CITY OF WEST LAKE HILLS, TEXAS
NOTICE OF BOARD OF ADJUSTMENT (BOA) SPECIAL MEETING
Wednesday, February 26, 2025 at 7:00 PM

AGENDA REPORT

1501 Wildcat Hollow: Discuss and consider action on a recommendation from ZAPCO on the following variance request to the Section 7.4.1 Cut/Fill Limits of the Drainage and Erosion Control Design Manual (Section 22.03.059 of the West Lake Hills Code of Ordinances):

RE: 1501 WILDCAT HOLLOW VARIANCE REQUEST
Application #2025-1247

Proposed Design I Variance 01

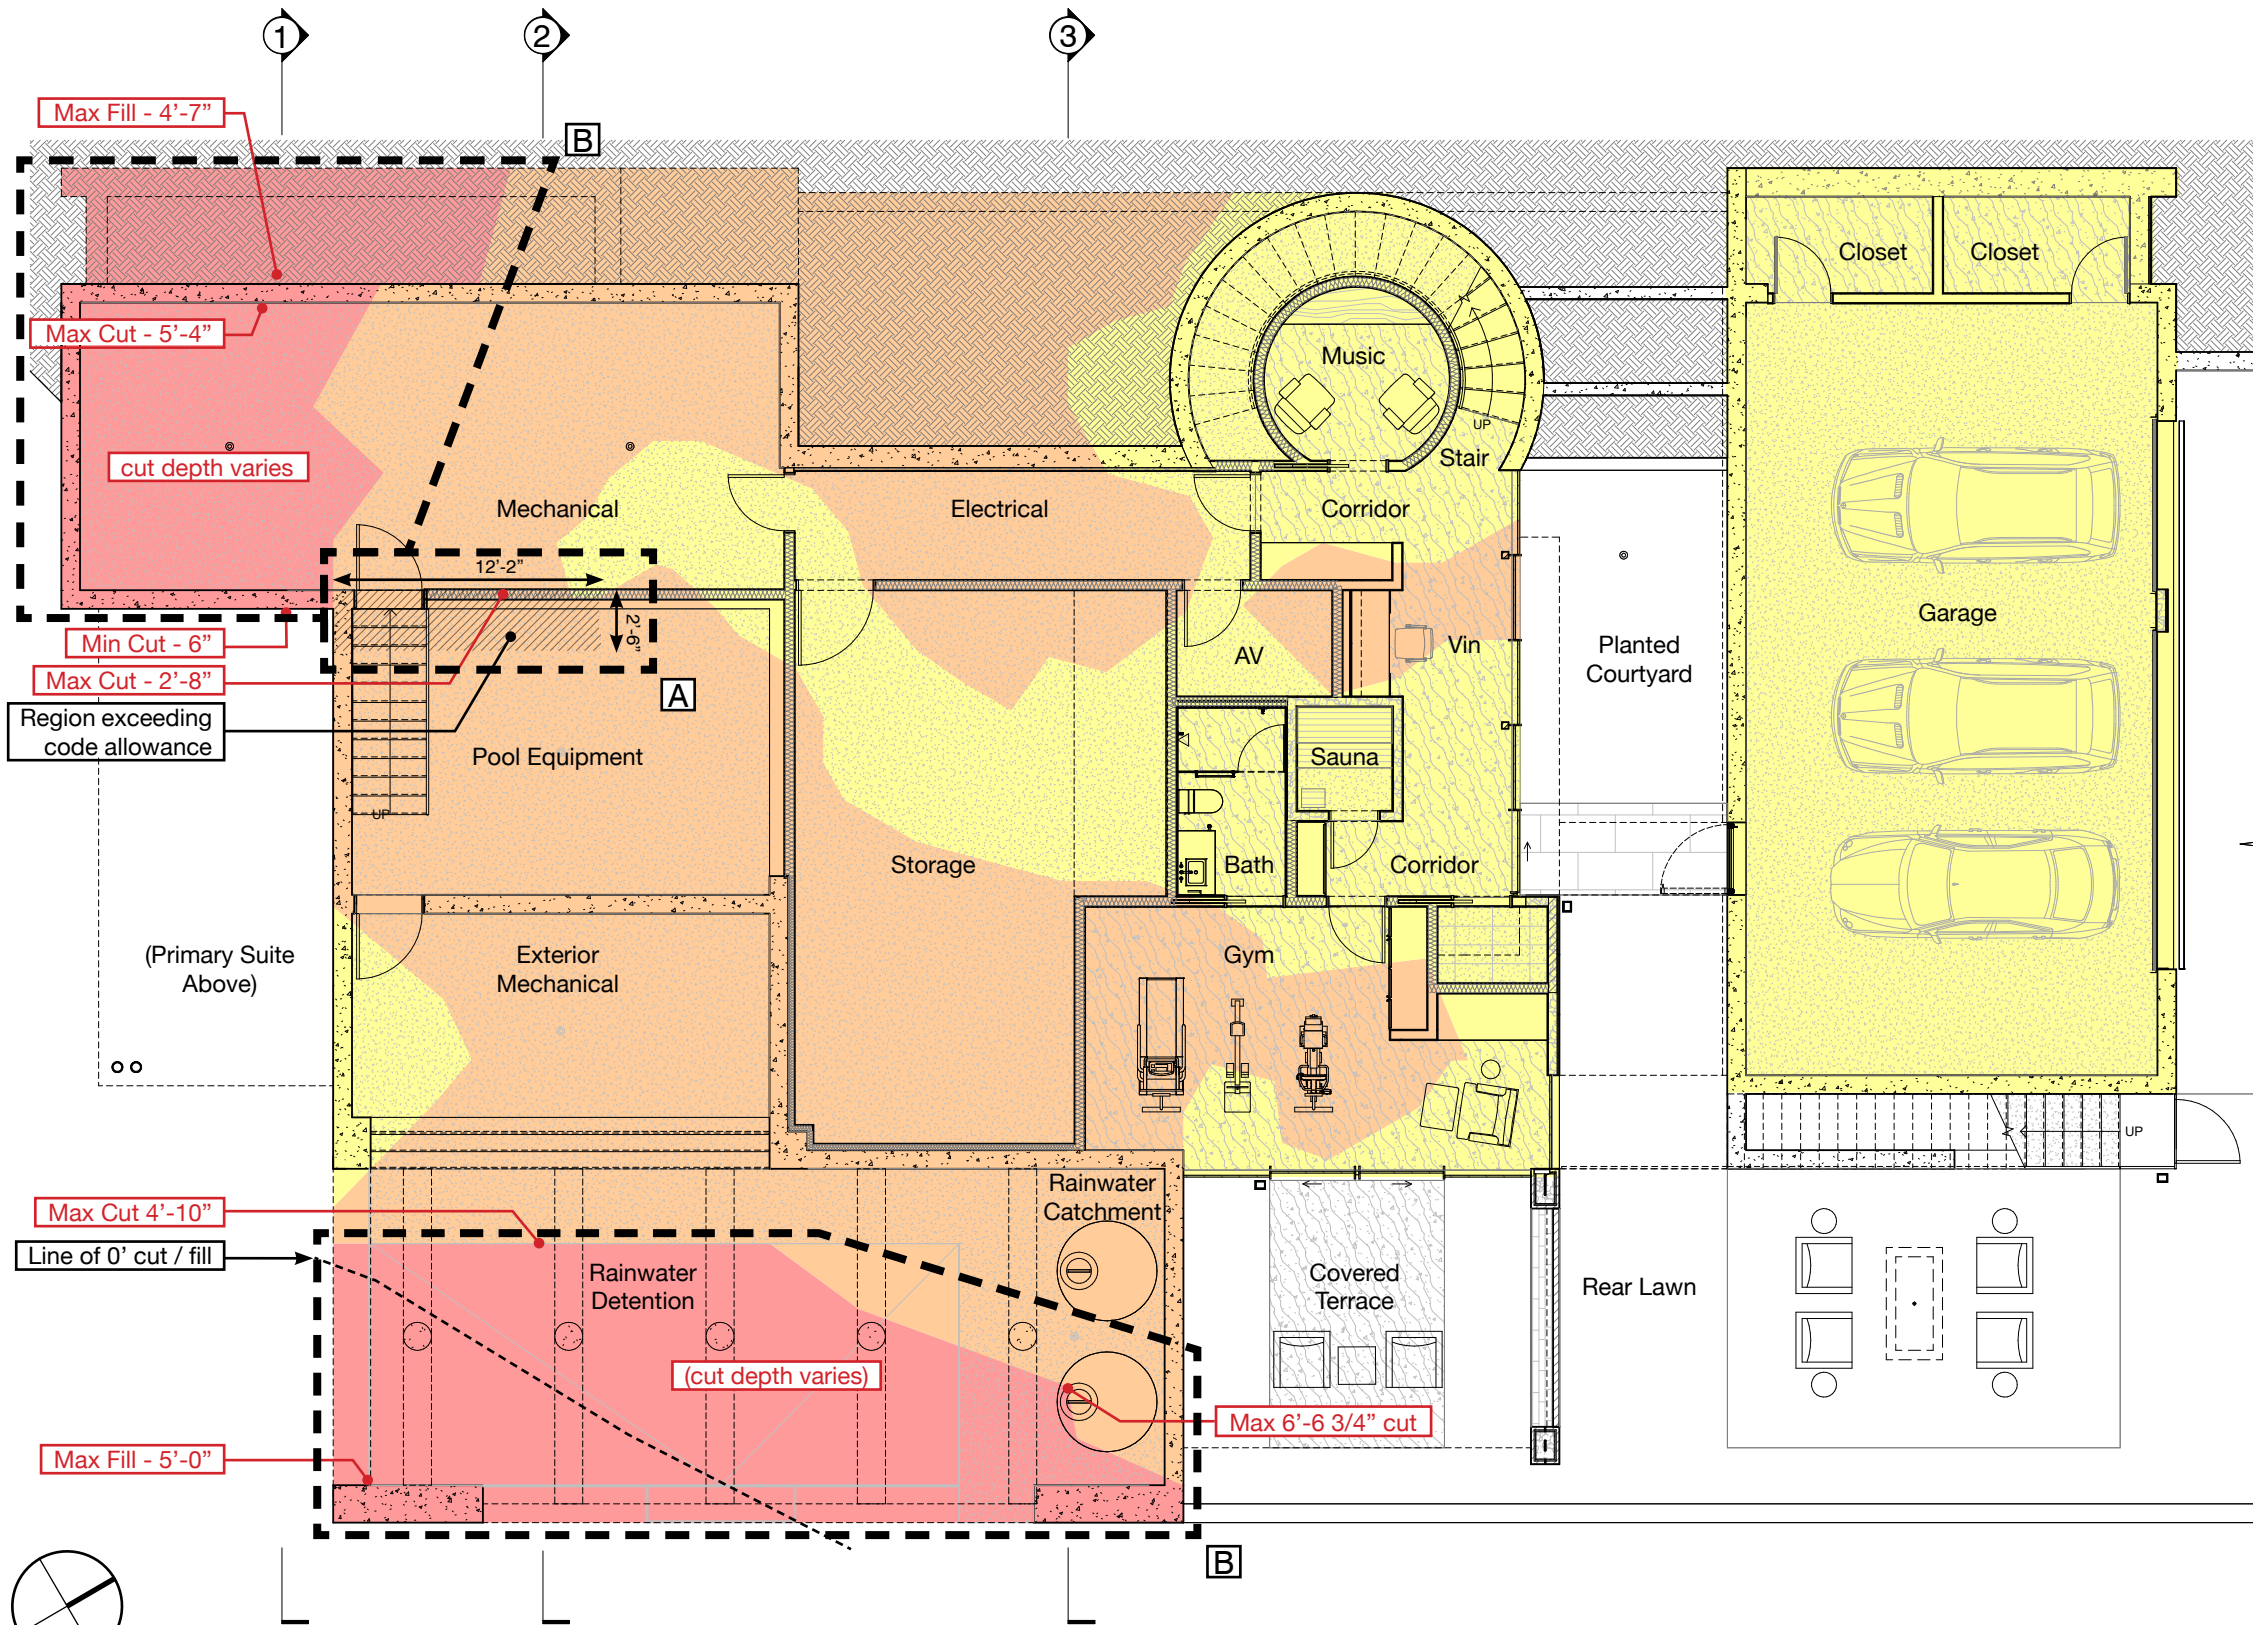
- A** Request to allow maximum 13'-0" (3'-0" beyond allowable) cut in areas where assumed natural grade slope is between 25%-35% slope, limited to areas under the building footprint.
- B** Request to allow maximum 7'-0" cut and 5'-0" fill in areas where assumed natural grade exceeds 35% slope, limited to areas under the building footprint and Rainwater Detention pond.

1. Chapter 7.4.1 – Cut/Fill Limits 25%-35% - **To allow for closed cut of up to 13 feet on a slope between 25% and 35% grade where the maximum closed cut allowed is 10 feet.**
 - a. We suggest that this variance is **approved.**
 - **Per Chapter 7 of the Drainage and Erosion Control Manual (Rev. 2020), the variance requested does not adversely impact the natural characteristics of the land and waterways of the watershed the property is located in.**
 - **Erosion control measures are proposed in place to limit impact to the watershed during construction.**

2. Chapter 7.4.1 – Cut/Fill Limits greater than 35% - **To allow for closed cut of up to 7 feet on a slope with a grade greater than 35% where no cut or fill is allowed.**

- a. We suggest that this variance is **approved.**
 - **Per Chapter 7 of the Drainage and Erosion Control Manual (Rev. 2020), the variance requested does not adversely impact the natural characteristics of the land and waterways of the watershed the property is located in.**

- **Erosion control measures are proposed in place to limit impact to the watershed during construction.**
3. Chapter 7.4.1 – Cut/Fill Limits greater than 35% - **To allow for closed fill of up to 5 feet on a slope with a grade greater than 35% where no cut or fill is allowed.**

- a. We suggest that this variance is **approved.**
 - **Per Chapter 7 of the Drainage and Erosion Control Manual (Rev. 2020), the variance requested does not adversely impact the natural characteristics of the land and waterways of the watershed the property is located in.**

Proposed Design | Variance 01

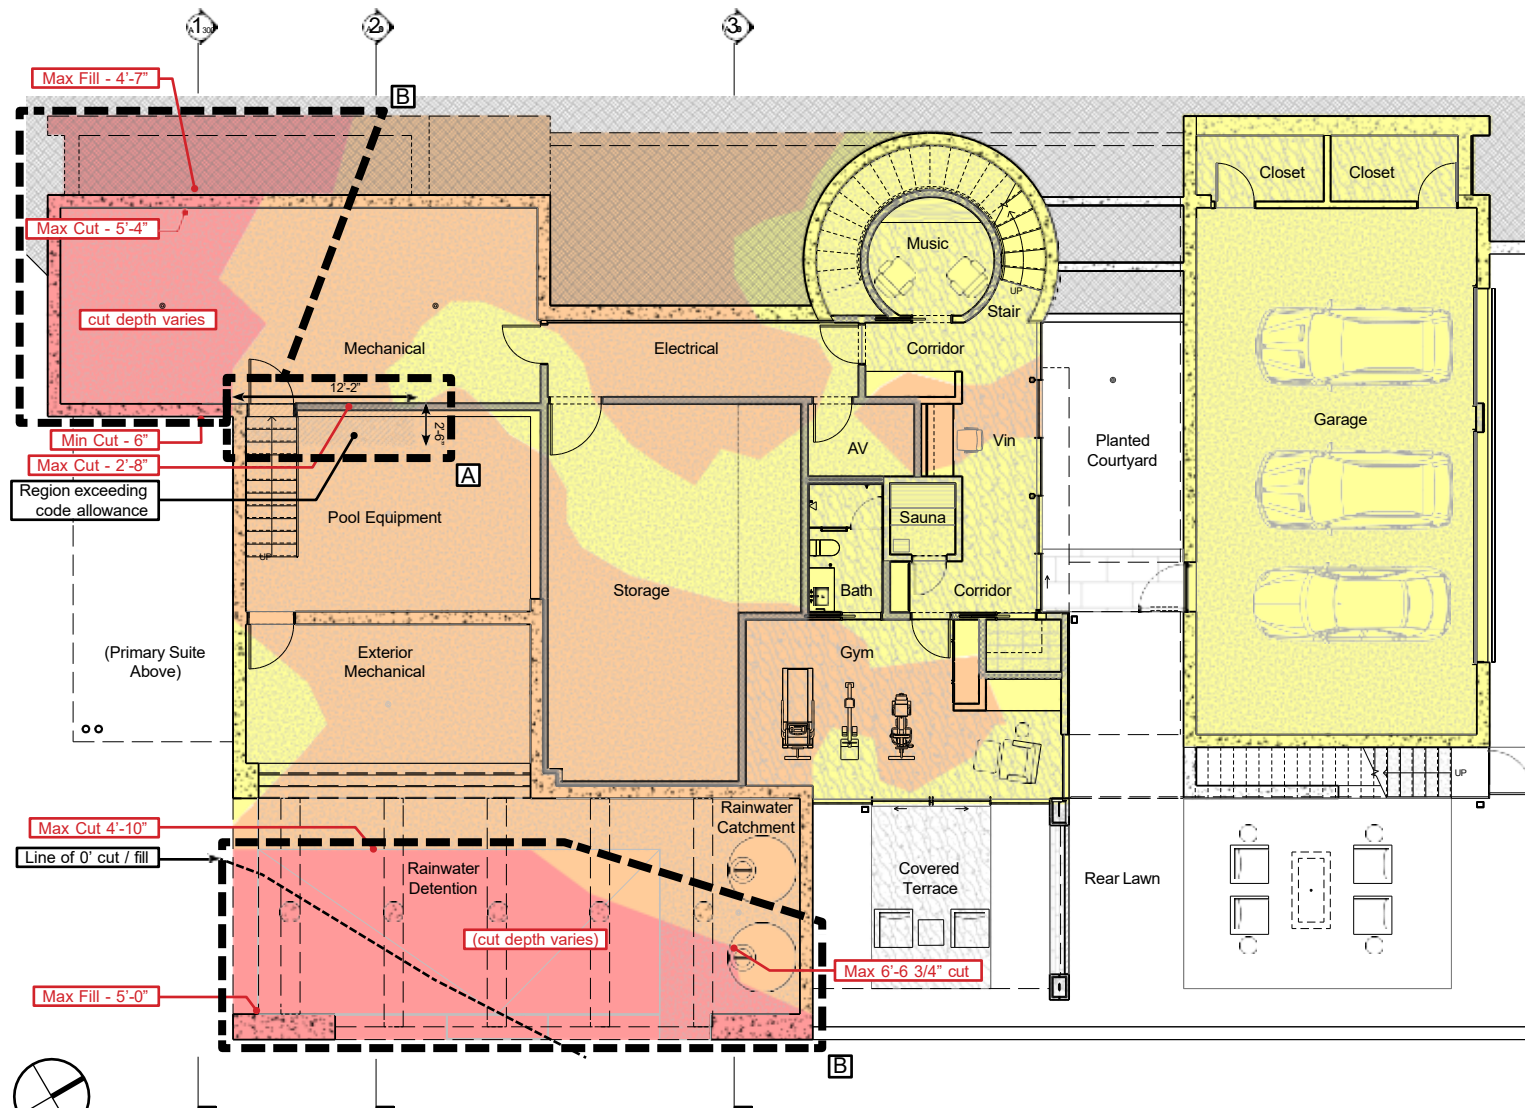
- A** Request to allow maximum 13'-0" (3'-0" beyond allowable) cut in areas where assumed natural grade slope is between 25%-35% slope, limited to areas under the building footprint.
- B** Request to allow maximum 7'-0" cut and 5'-0" fill in areas where assumed natural grade exceeds 35% slope, limited to areas under the building footprint and Rainwater Detention pond.

- Staff and the city engineer recommend approval of the variance requests
 - Due to the natural topography and two front setbacks.
 - The variance would not adversely impact the natural characteristics of the land and waterways of the watershed the property is located within.
- Public Comment:
 - Two letters of support were received by the City.
- The ZAPCO reviewed the item at the regular meeting on February 19, 2025 and recommended approval by a vote of 5-0 due to the hardship of the topography.
